# REGULATORY INFORMATION DISTRIBUTION SYSTEM (RIDS)

SUBJECT: Forwards comparison of draft STS w/snubber functional test sampling plan.

Re: Snubber Functional Test  
Sampling Plan

# SNUBBER FUNCTIONAL TEST SAMPLING PLAN EVALUATION

Subject Confidence Limits of Sampling Plans

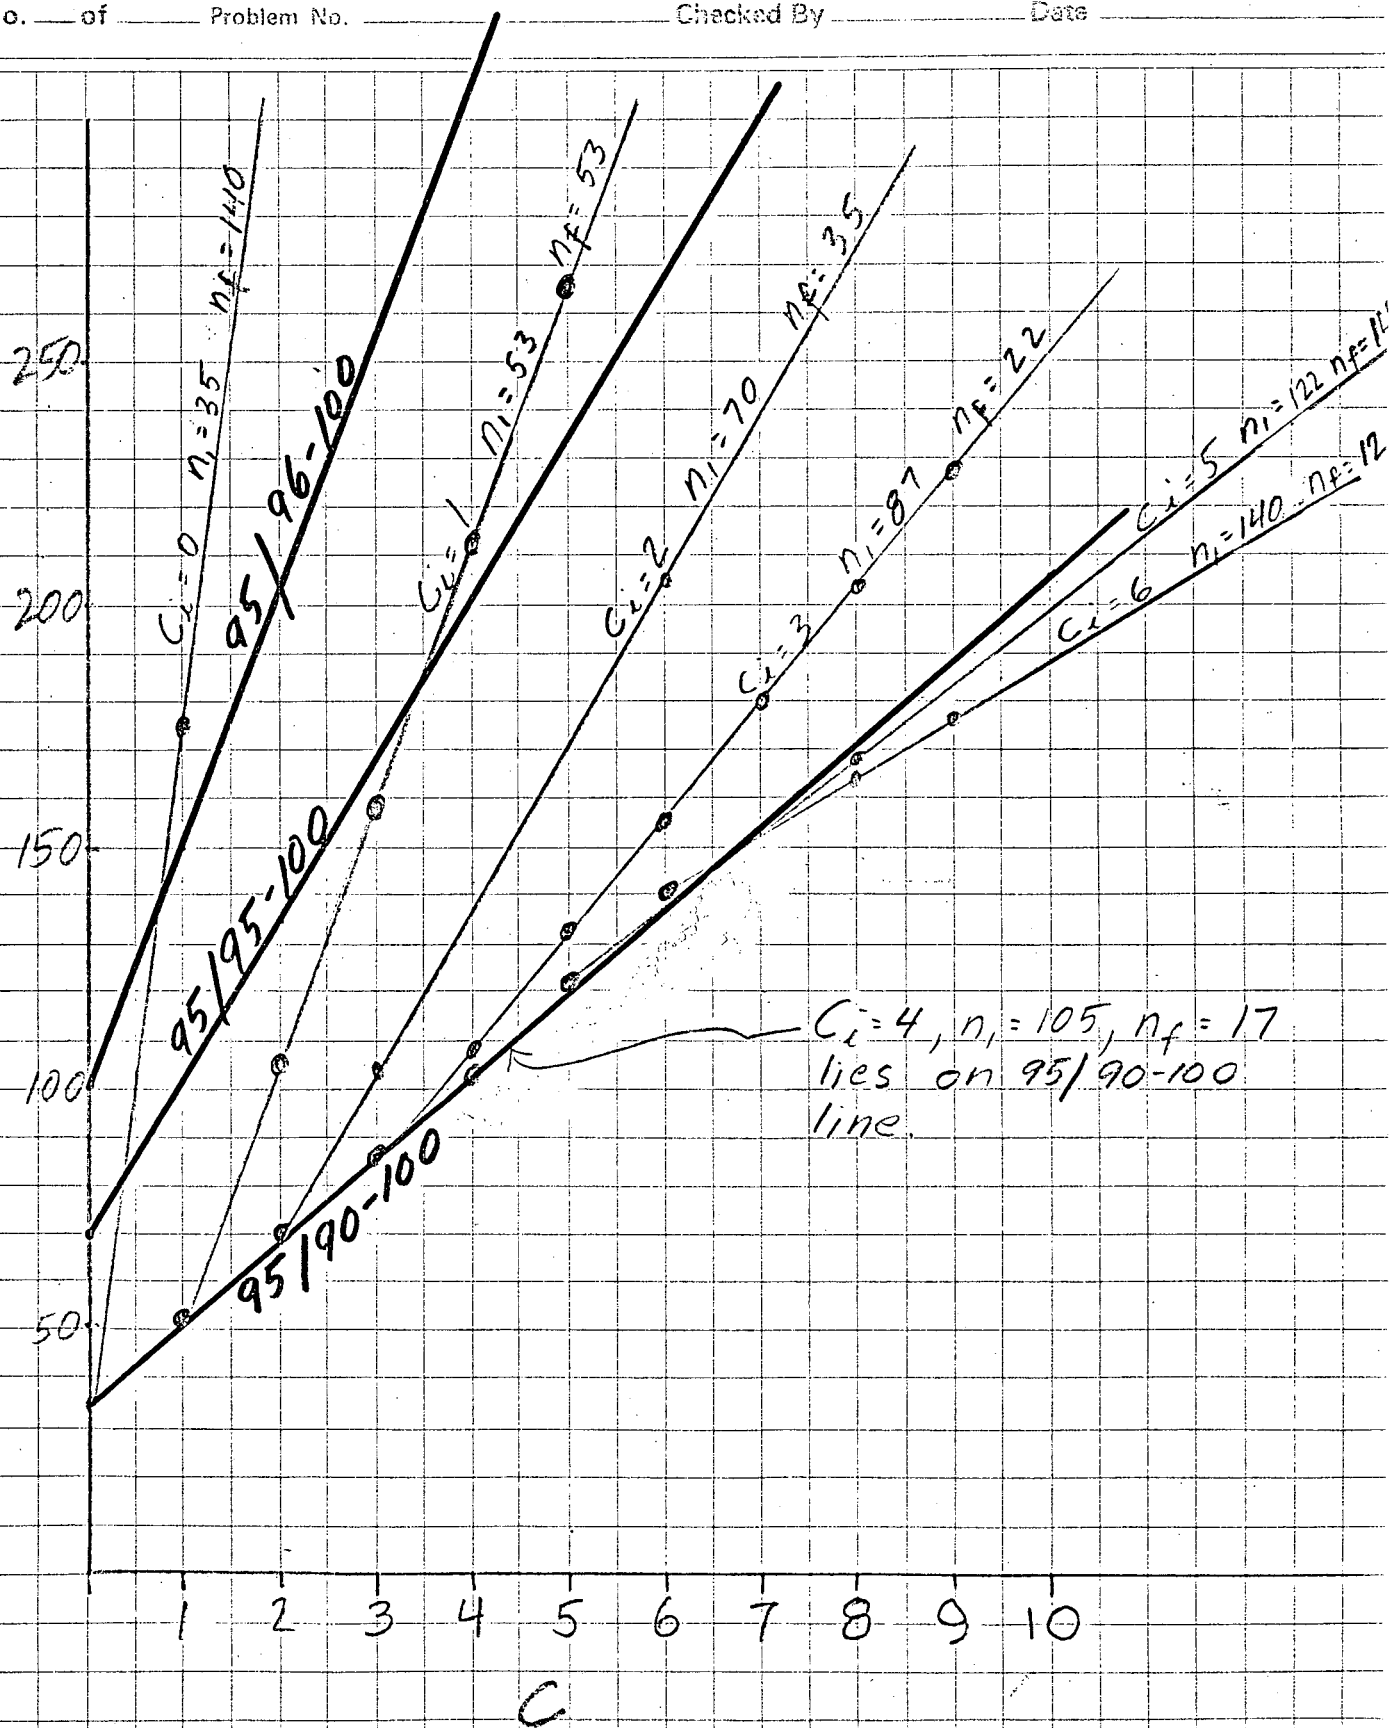
The first step in making an evaluation of these plans is to narrow the draft plan down to its viable alternatives. All initial values of  $c_i$  greater than 4 have very large initial samples and do not provide adequate levels of protection if follow-on samples are required. Therefore, these  $c_i$  are not viable and will not be considered further. This relationship is shown in Figure 1.

Probability of Passing Bad Lot  
on First Test

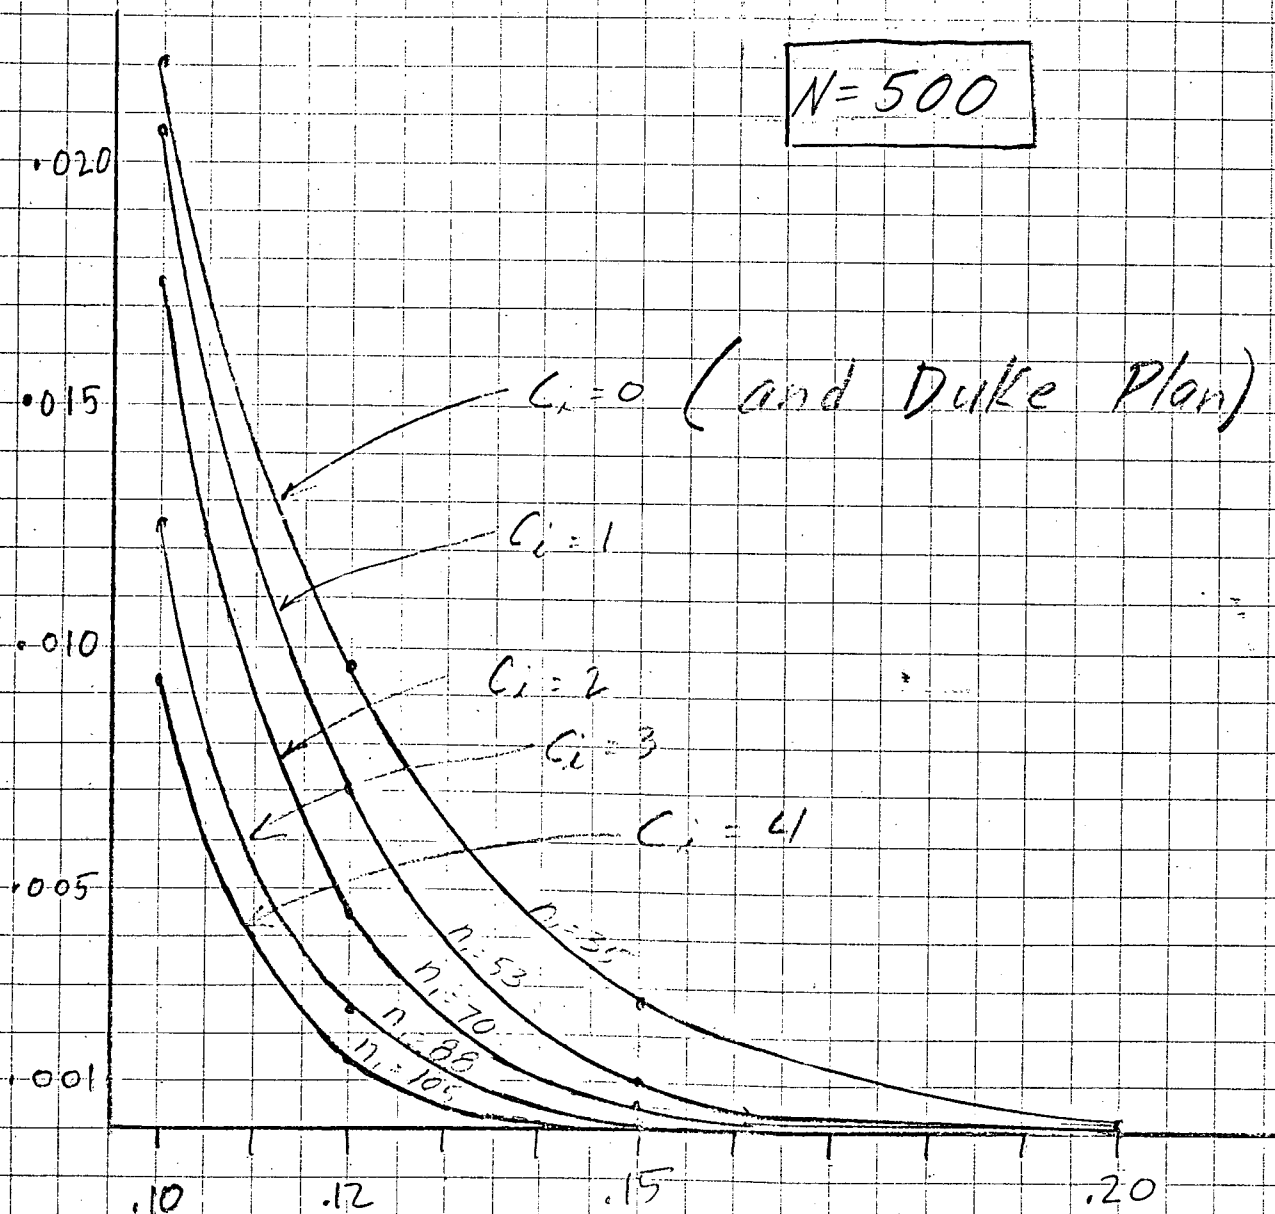
Figure 2 shows the probability of accepting populations of 10% or more out of calibration snubbers for various initial values of  $c_i$ . The Duke plan corresponds to  $c_i = 0$ . As can be seen, the probability<sup>(2)</sup> of accepting bad lots decreases with increasing  $c_i$ . In all cases, the probability of accepting a bad lot is very small. For example, a population of 500 snubbers that is marginally acceptable ( $D/N = .10$ ) will be accepted only about two times in 100 under the most liberal plan. A clearly unacceptable population with 20% out of calibration snubbers ( $D/N = .20$ ) will be accepted only about three times in 10,000 under the most liberal plan.

Our conclusion is that all sampling plans reject bad lots with a high degree of confidence, but that the draft plans are marginally better at this than the Duke plan.

# Probability of Accepting Good Lots on First Test

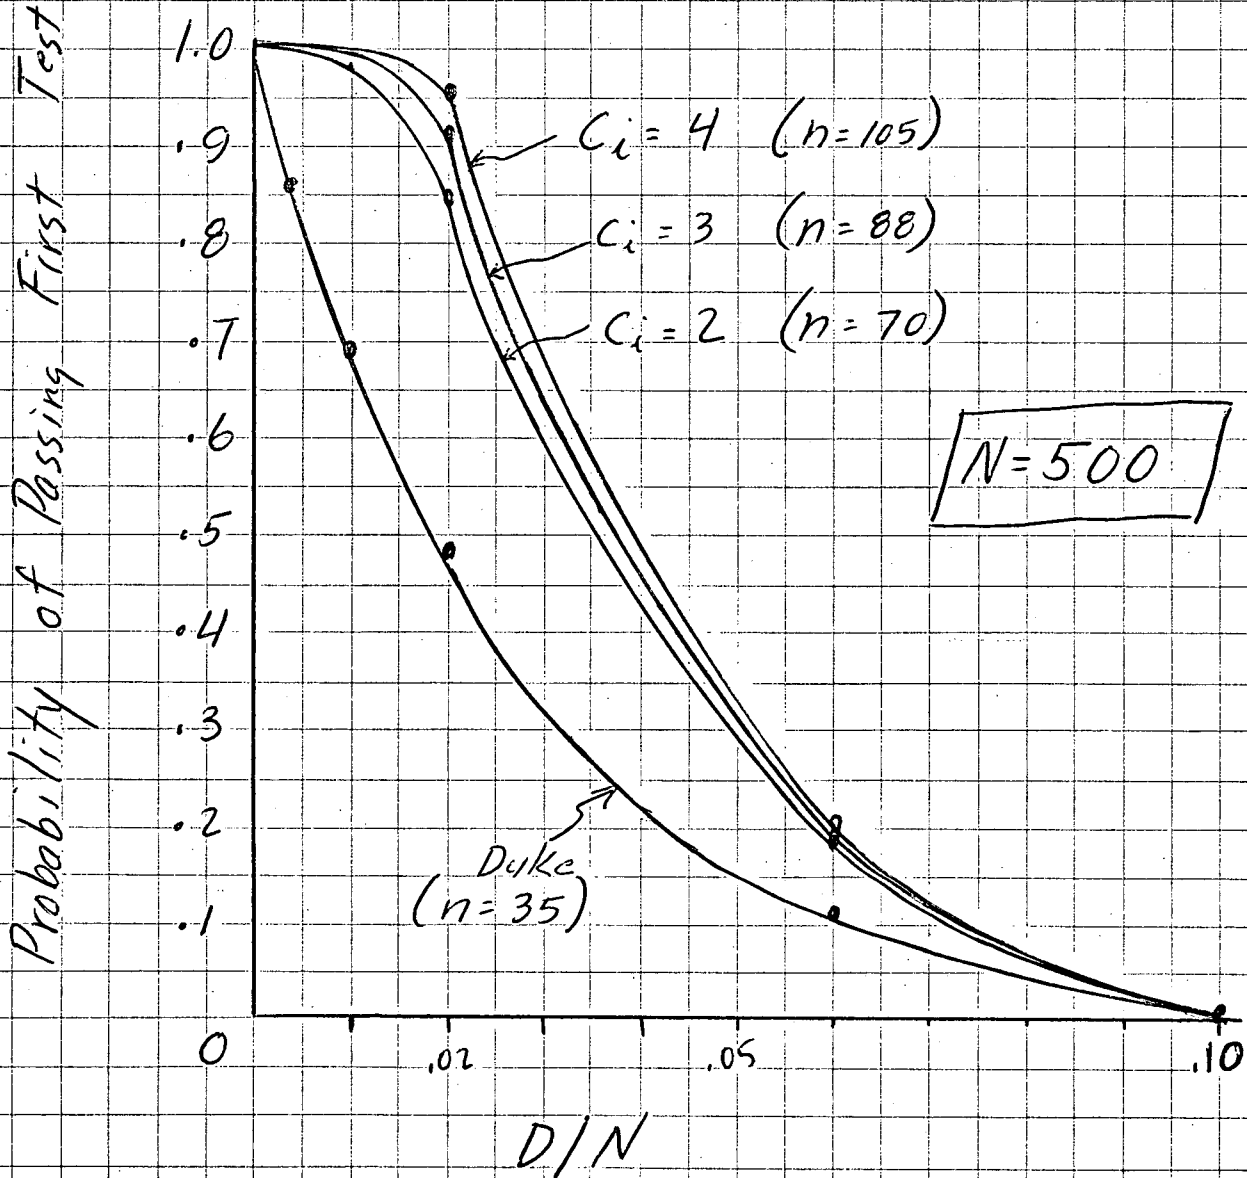
To have a reasonable chance of passing the first test under any plan, the population must be considerably better than the acceptance criteria. Figure 3 shows this relationship for the plans under consideration. For a population of 500 snubbers, to have a 50-50 chance of passing the first test, the population must have fewer than 4% out of calibration snubbers. For purposes of further comparison, we will take a "good" population as one with 2% out of calibration snubbers ( $D/N = .02$ ).

FIG. 4

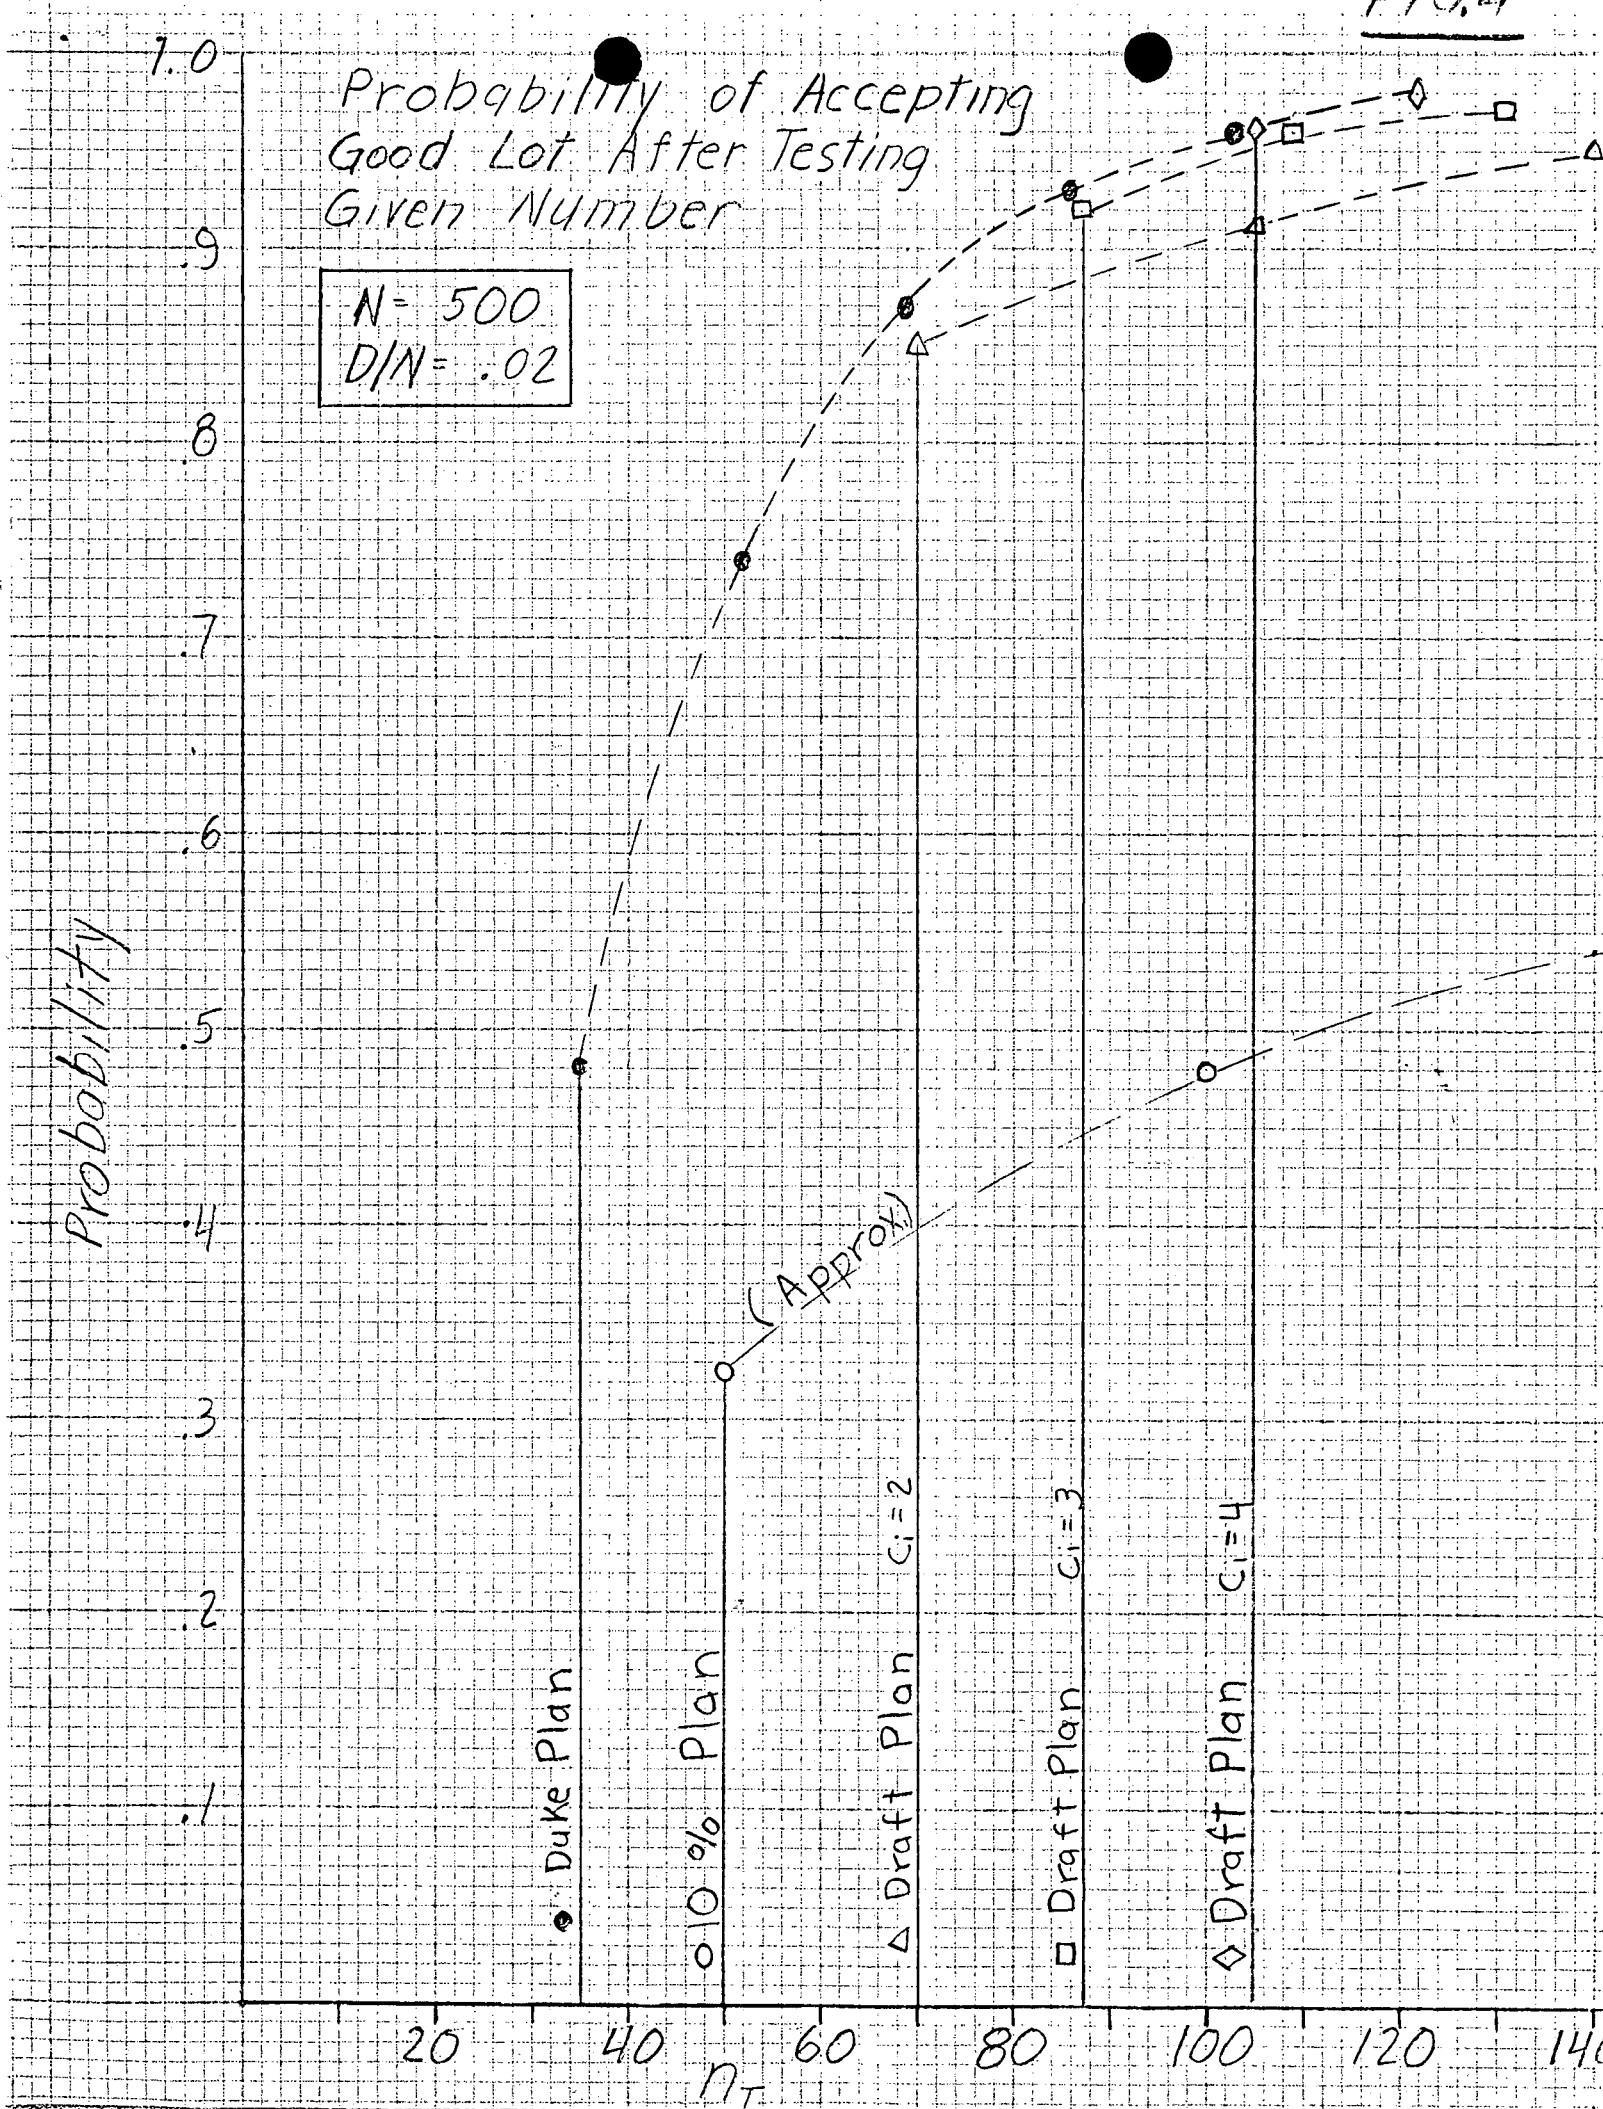
Figure 4 plots the probability of acceptance versus the cumulative number of snubbers tested. The Duke plan exceeds the draft plan in probability of accepting good lots for  $c_1 = 2$  and  $c_1 = 3$ , and appears to roughly coincide with  $c_1 = 4$  in this respect. (For information, an approximation of the 10% plus 10% sampling plan is included to show that it operates poorly on large populations.)

Our conclusion is that all plans under consideration are capable of accepting good lots with a high degree of confidence. However, for any given number tested, the Duke plan is somewhat more efficient than the draft plans.

# Probability of Testing Exactly a Given Number

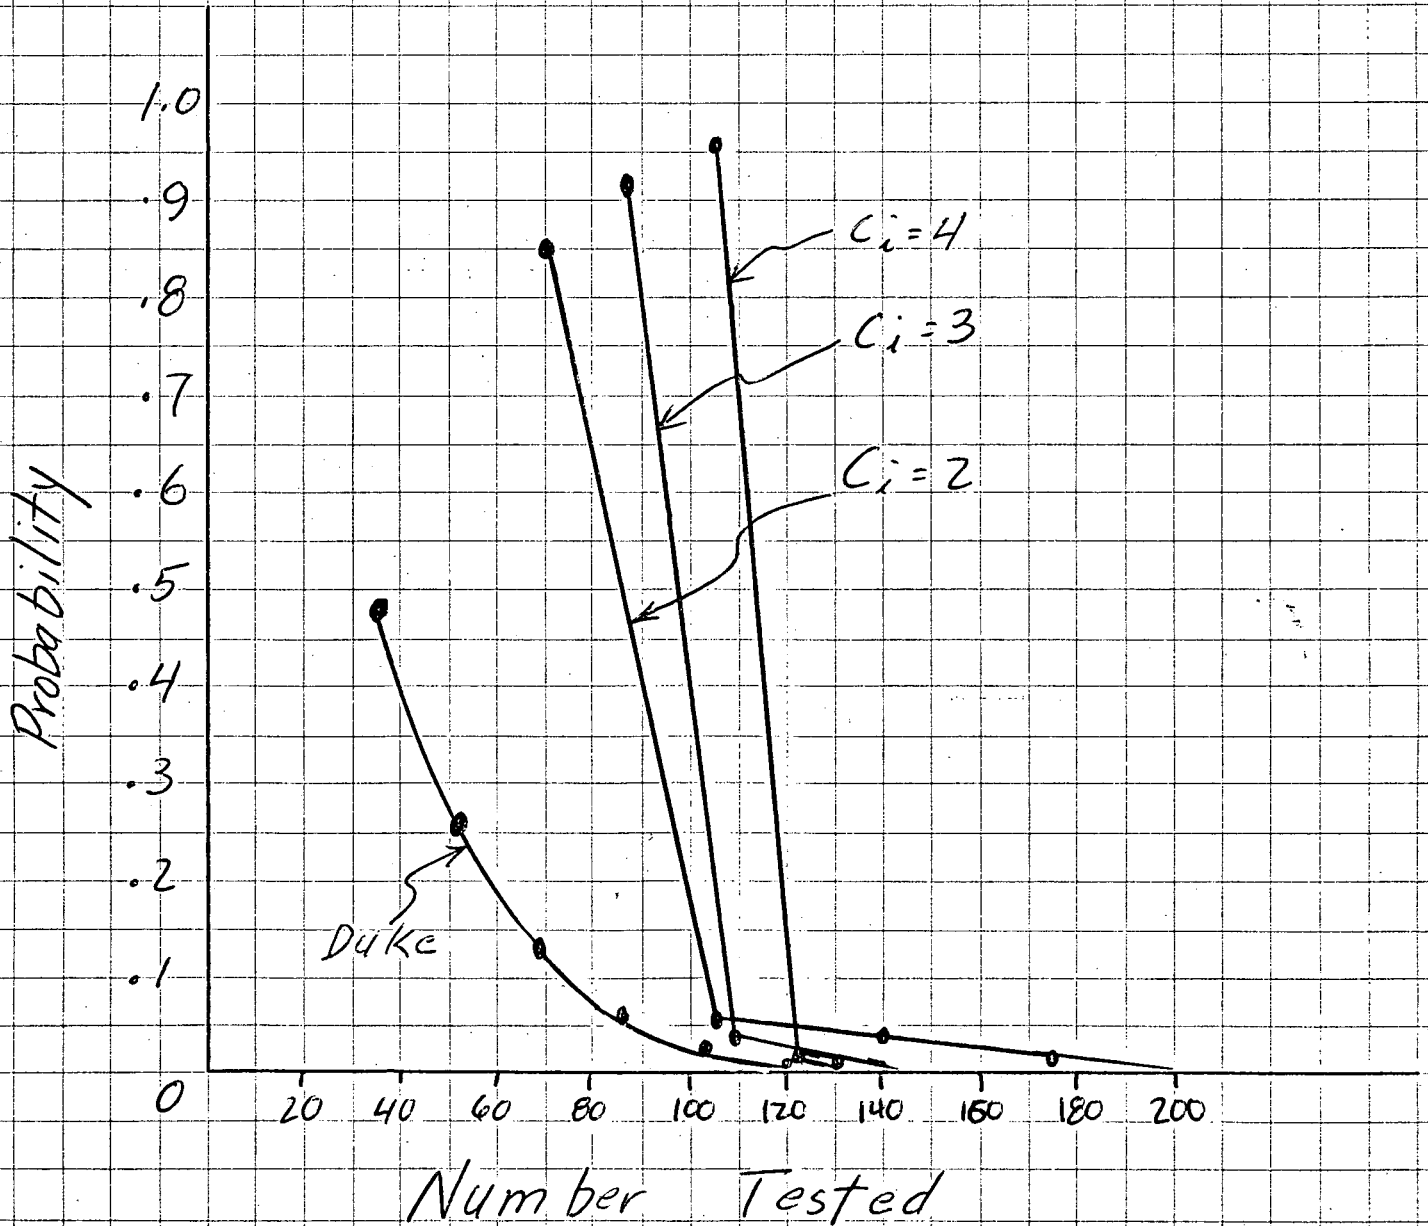
Figure 5 shows the probability of testing exactly a given number for each plan under consideration. Using this information, Figure 6 has been developed which shows the expected average number of snubbers tested 96 per cent of the time. The remaining four per cent are those low probability cases requiring a large amount of testing. As can be seen from Figure 6, the Duke plan will average 48 snubbers tested while the draft plans require averages of 73, 84, and 105 respectively.
